ADDENDUM No. 2

PROJECT NAME: Culebra/ Helotes Creek Greenway-
Shaenfield Road to Culebra Creek Park

DATE: October 21, 2014

Job Title CULEBRA HELOTES By D.J.M.
CREEK GREENWAY Ck. S.J.F.
 Date 10-10-14
 Subject ADDENDUM #2 File CHTS201
 Job 02-243-00
 Sht. 1 of 2

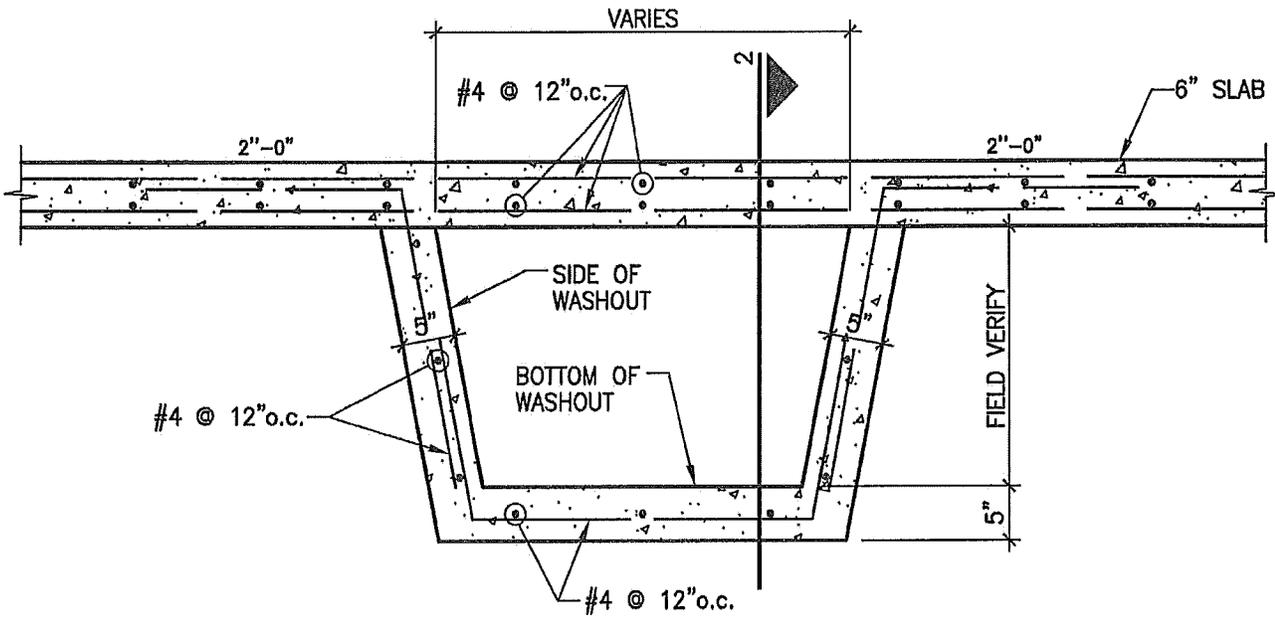
Item No.1 Structural Details- Structural details add the two details to be utilized at wash outs at trail crossing along the Helotes Creek bottom. (see attached drawings)
